North Campus Faculty Housing Phase II  
Project No. FM110407L/986315

**Addendum No. 6**

ADDENDUM NUMBER 6  
to the  
CONSTRUCTION DOCUMENTS

BUILDING 700A REVERSE : SECTIONS 2

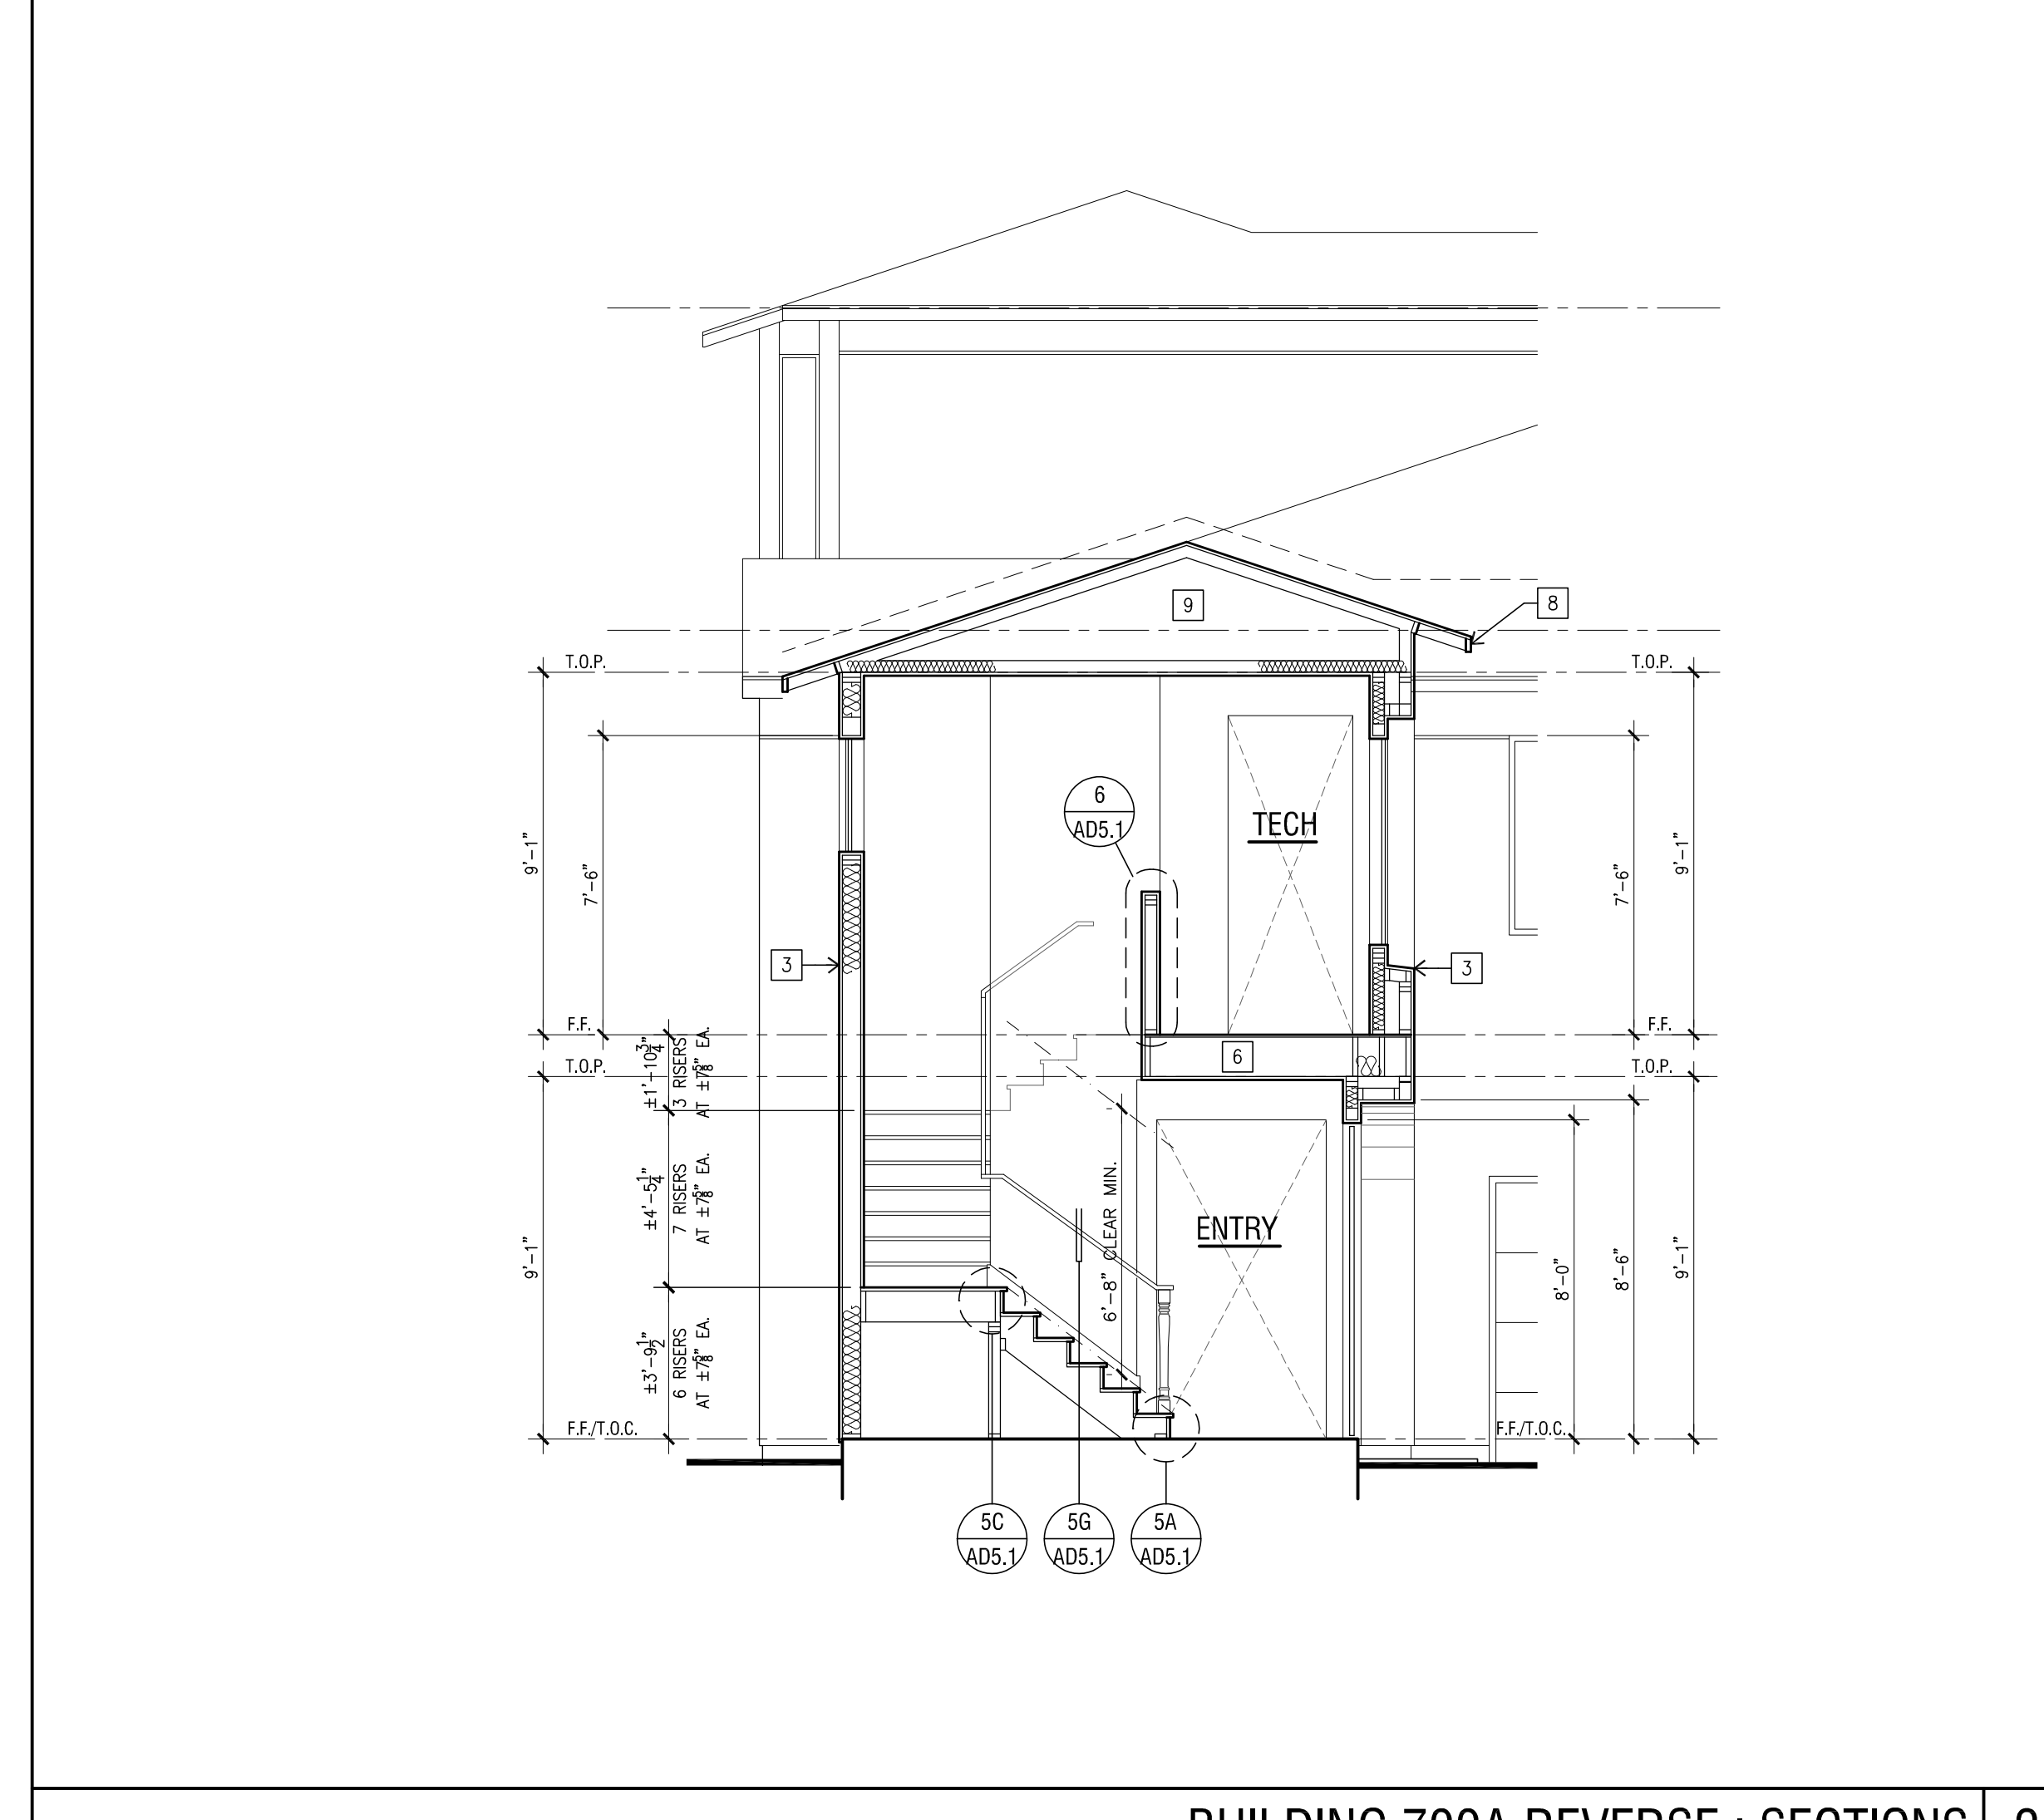
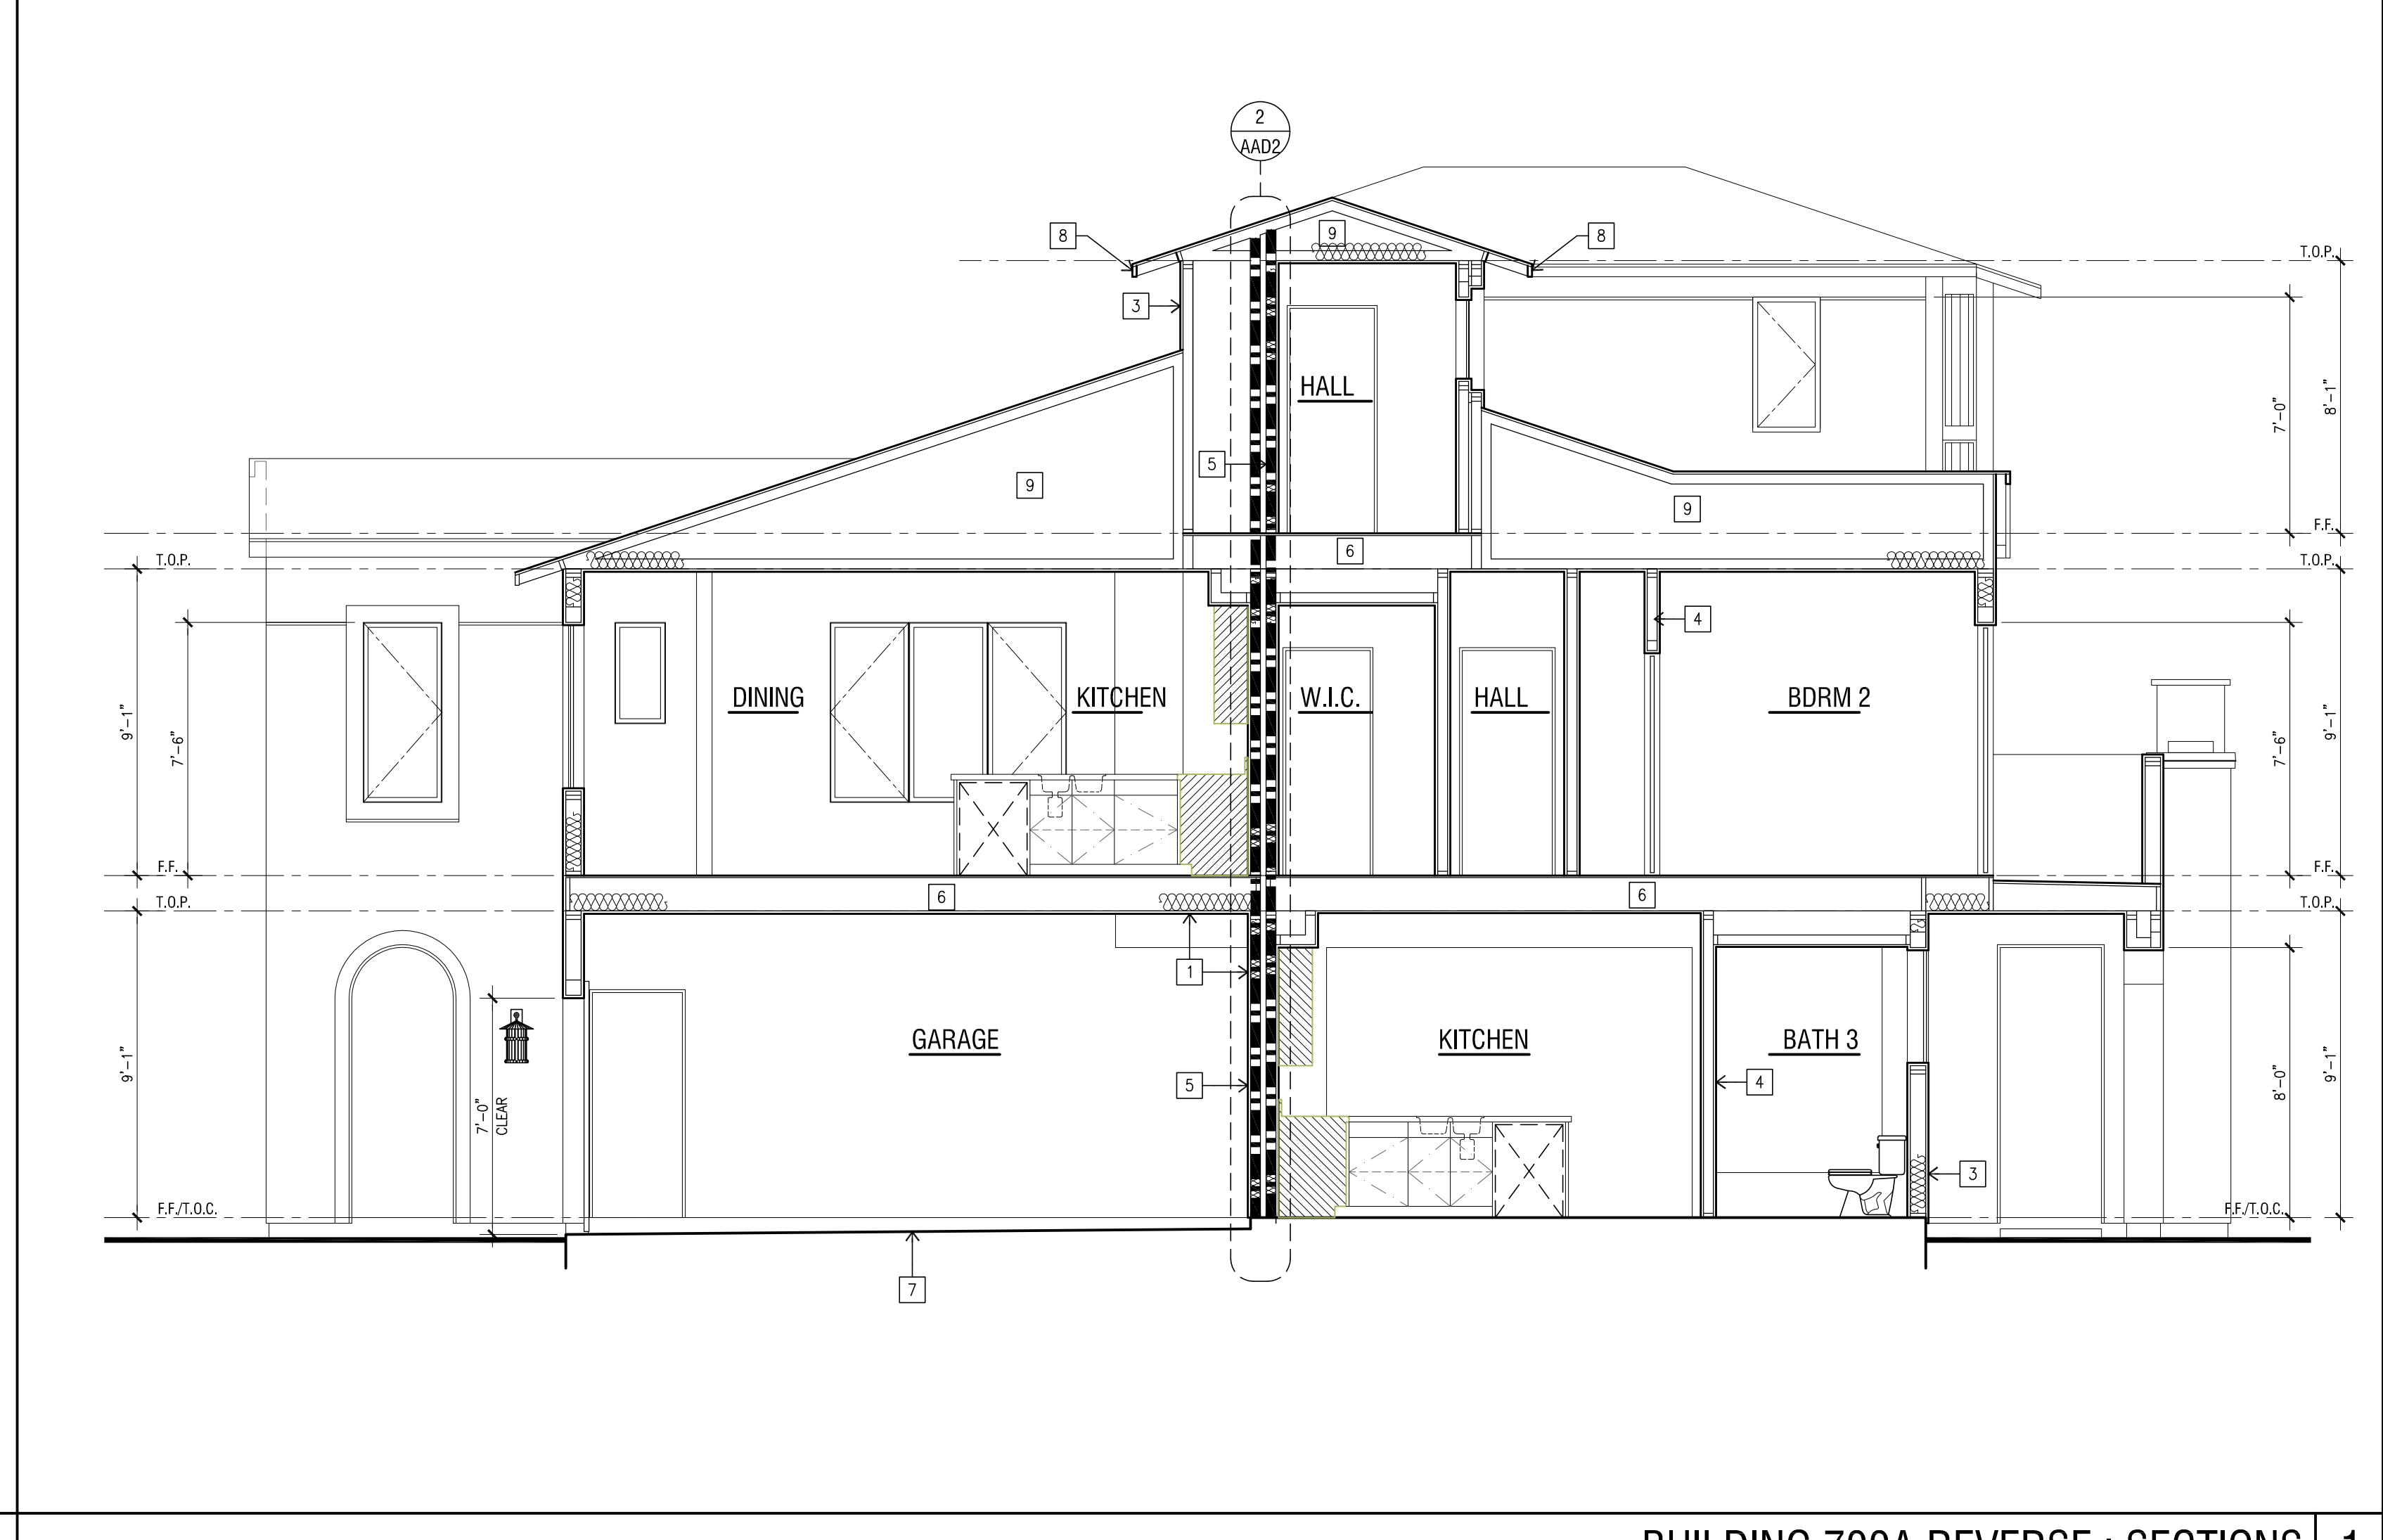
Sketch 5 of 8	Building 600A: Reverse: Sections
Sketch 6 of 8	Building 600B: Sections
Sketch 7 of 8	Building 700A: Sections
Sketch 8 of 8	Building 700A: Reverse: Sections
